Reference: brge00140201a

**Foundation Investigations  
Highway 69 Route Selection Study  
GWP 5377-02-00**

Attached please find three hard copies of the final Preliminary Foundation Investigation & Design Report for Selected Structures, and one electronic copy of the same in the enclosed cd.

We have incorporated into the final report the results of the additional drilling after the presentation of the draft report, and amended the report as per MTO's comments. The amendments are as follows:

Figure 1 – Site Map

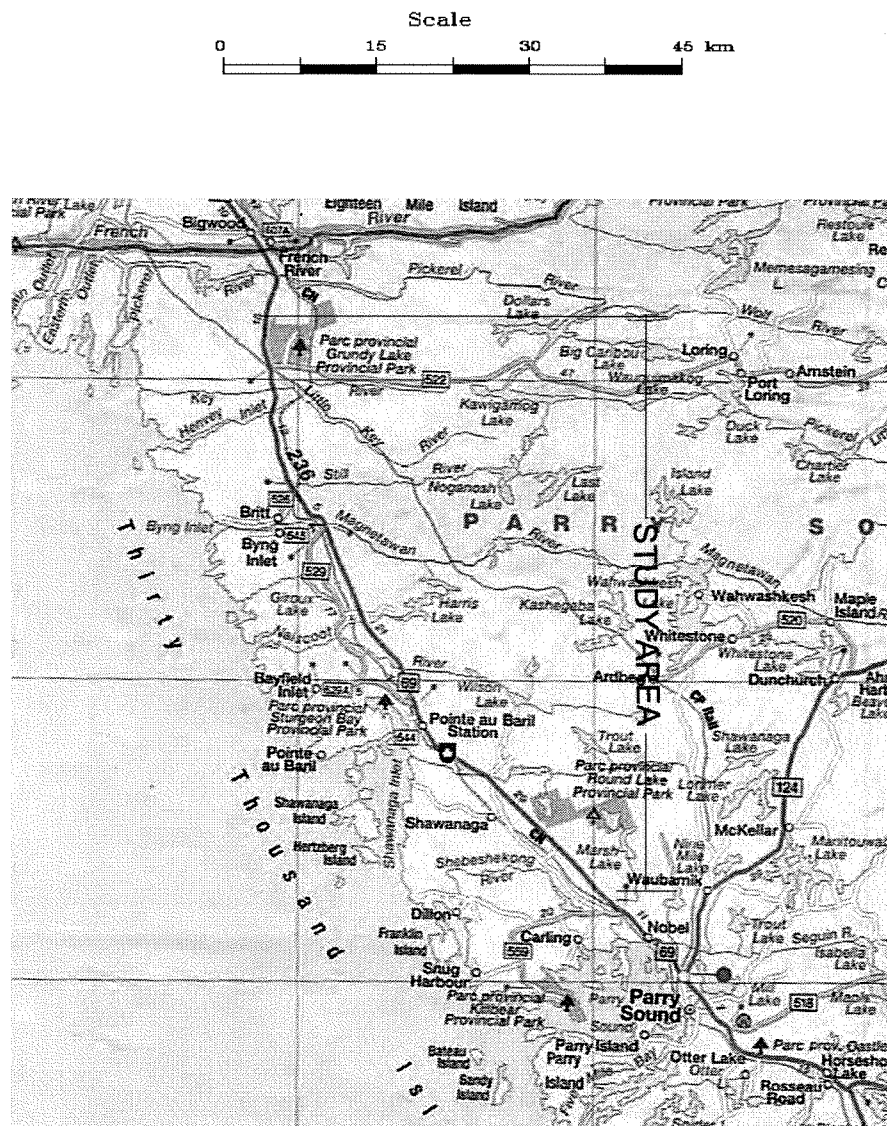
22. The report is signed by two professional engineers.
23. A scale has been provided for the Site Map.
24. Figures 3 to 8 have been revised.
25. A page of explanation notes has been added.
